116, 118, 120-124, 126, 128 and  
130 South Road; 47-51 Villeroy  
Street, Brighton East and 1-5  
Imbros Street, Hampton

Planning Permit Application  
No. PA2201785

Officer Assessment Report  
Development Approvals & Design

Figure 15 – CASC fencing

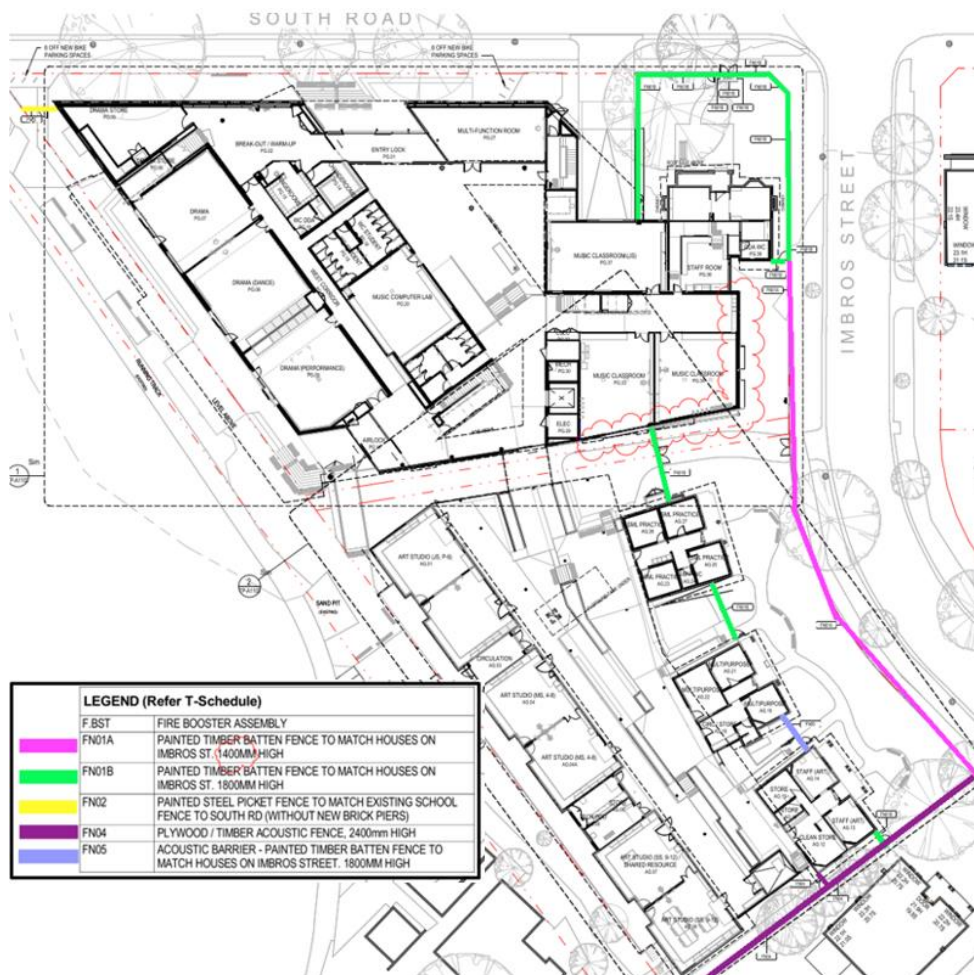
129. The fence plan at Figure 15 (marked up by DTP) shows the layout of proposed fencing to the CASC. However, elevation details should be clarified, and a permit condition should require detailed fence plans to clearly show each new fence proposed.

Figure 16 – 7 Imbros Street interface

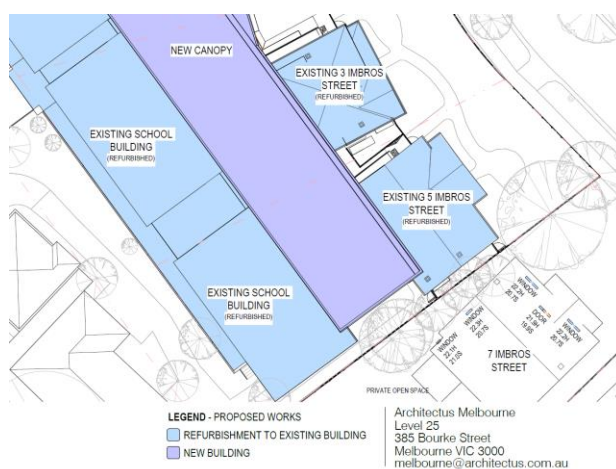
149. The setback of the proposed canopy exceeds the setbacks that would be required for a wall of a residential development. Accordingly, this is considered an indicator that the visual bulk of the canopy would be suitably mitigated. It is noted that mere visibility does not make new built form unsuitable.
150. The common boundary is landscaped and screened from the school grounds and therefore views are somewhat screened from 7 Imbros Street. The existing school building already interfaces with the rear private open space interface of the residential property.

151. Overlooking will be restricted given the location of the wall to the kiln and a screen extending along most of the southern interface of the deck located beneath the new canopy.

Figure 17 – Approximate location video screen (circled)

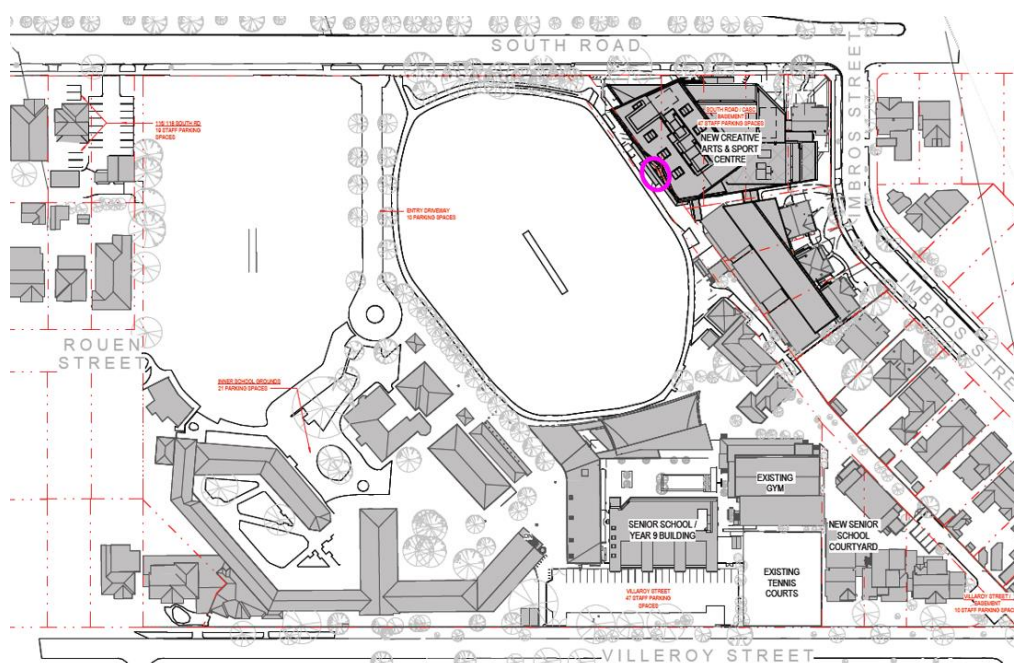
156. As noted above, the score board to the CASC is located on the west elevation (shown in Figure 17), facing inward to the subject site. This positioning, along with limiting to video only, will minimise impacts to the public realm and surrounding residential properties. Permit conditions will ensure appropriate mitigation.

132. Given the plans refer to a 'future AV screen', i.e. an audio/video screen, a permit condition will require all relevant documents refer to a score board only with no audio or speakers as the applicant has advised will be the case. Permit conditions will be included to address light and operation.

Figure 18 – Facilities Compound buggy access

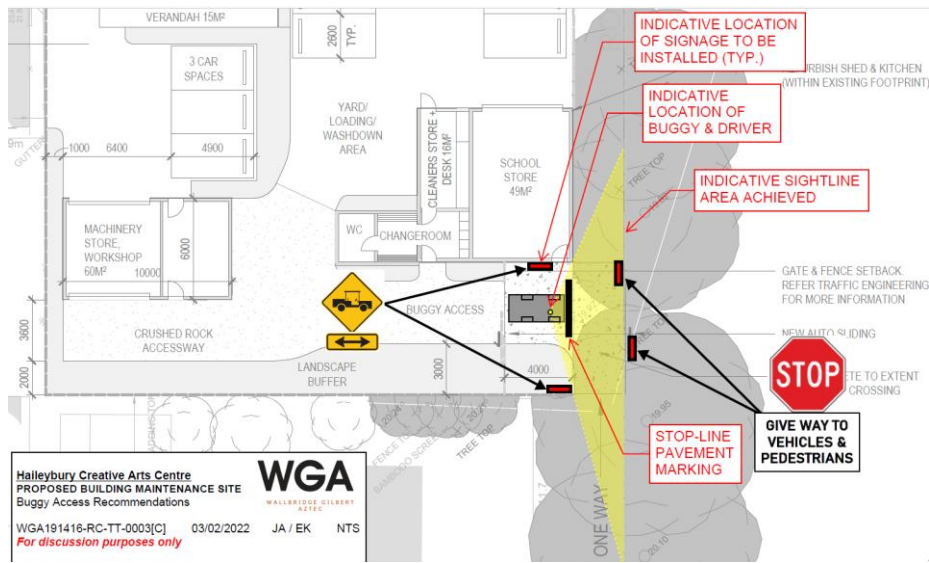
209. The submitted sketch diagram below illustrates the proposed type and location of custom signage and linemarking to ensure drivers, pedestrians and bicycles in all travel directions are aware of operating conditions.

210. Permit conditions will ensure that the abovementioned recommendations are adopted.

Figure 19 – Waste storage areas as per WMP

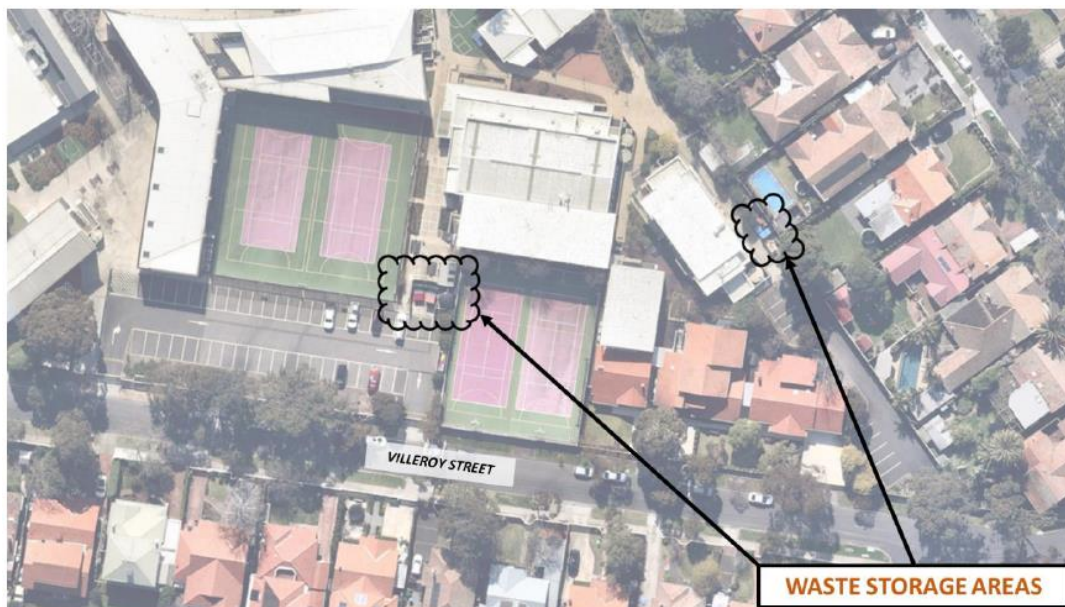
The above points are inconsistent with the TCPMP. As such, a permit condition will require that the WMP be amended to ensure waste collection times are consistent with conditions 16k and 16l of Planning Permit 2005/686/1.

Figure 20 – Cantilever over drainage and sewerage reserve

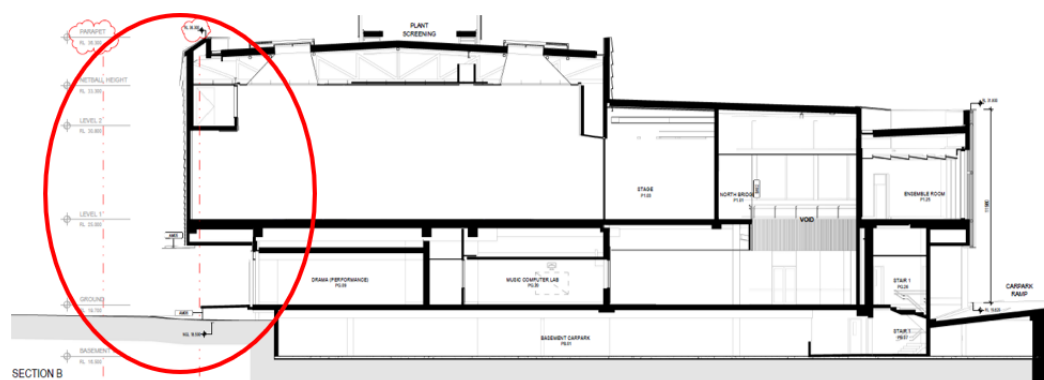
223. The word “on” in its ordinary and everyday meaning would be understood to mean “on” and not also implied to mean “on or above”.

224. Further, the fact that the covenant runs on land above drainage infrastructure, and the reference in the covenant being shown as a “drainage reserve” in the historical title, indicates that the intention of the parties when creating the covenant was to prevent the erection of any building or buildings on the land that would inhibit access to the drainage infrastructure, or otherwise frustrate good drainage outcomes of the school or neighbouring properties. The cantilevering of the building would allow access to the drainage infrastructure.
